Public Service Commission

May 21, 2015

The Reclamation Division has completed its review of application for Revision No. 30 to NACT-8503. This revision proposes to delete 35.083 acres that have not been disturbed by Coteau's mining activities. The following items must be addressed prior to revision approval.

Figure 1

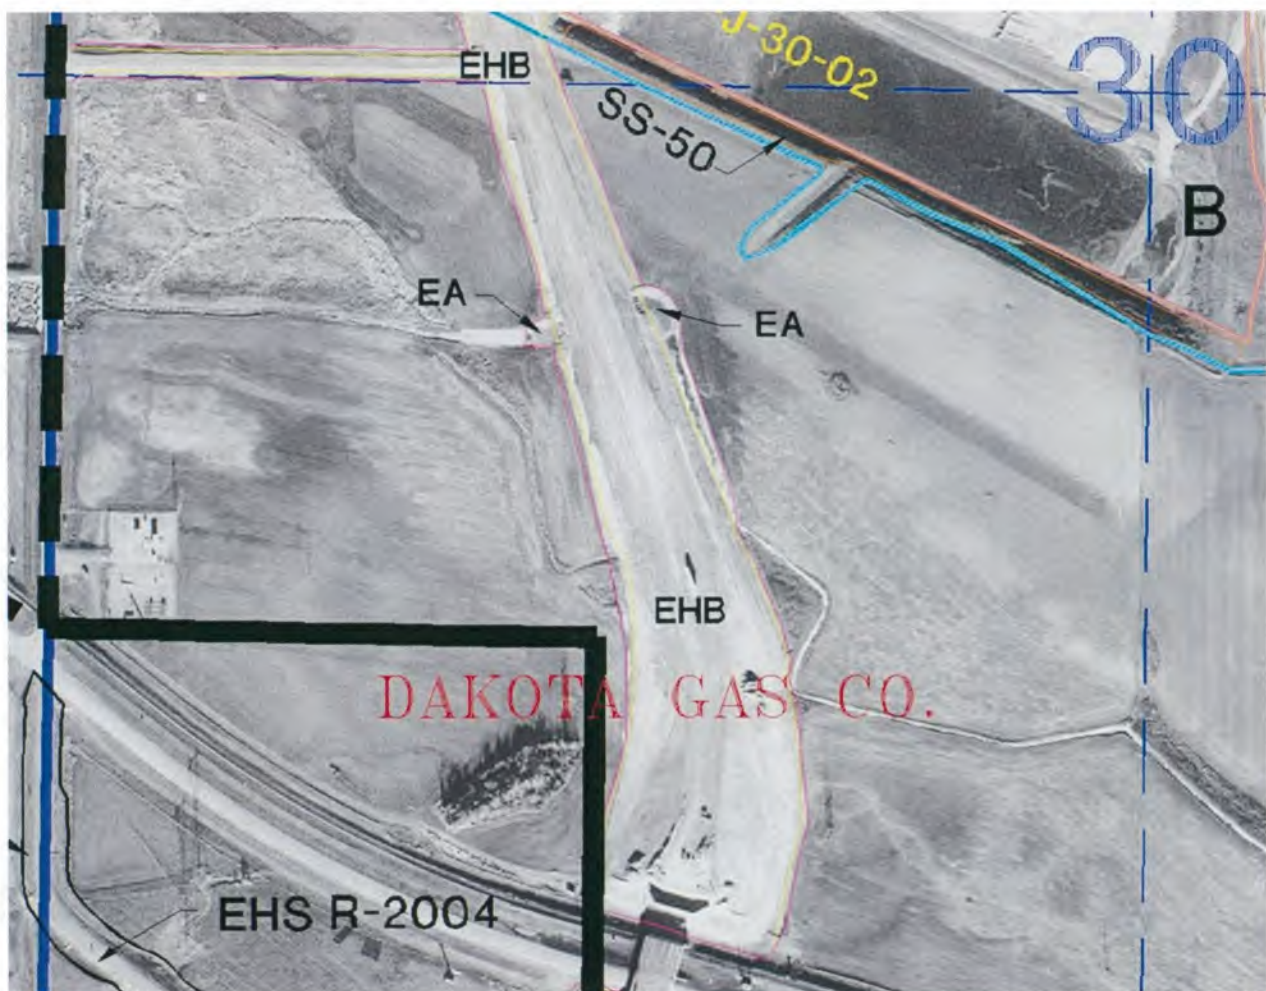
1. Coteau is proposing to delete 35.083 acres from Permit NACT-8503 with Revision 30 but it appears that mining related disturbance may have occurred west of the box culverts, according to aerial photography included with the 2004 annual mine map (See Figure 1 below). It appears a diversion channel was cut or otherwise modified to route West Antelope Creek to the box culverts and it is not clear if low flow passes through the box culverts or through the original channel of West Antelope Creek. NDAC 69-05.2-16-07(4) requires that natural stream channels be restored after being temporarily diverted. Therefore, if low flow is being diverted from the original stream channel, then the diversion should be retained in the permit. Please review and revise the deletion boundary if necessary or clarify/demonstrate that the area was not disturbed by mining activities. (GAW/FSE)
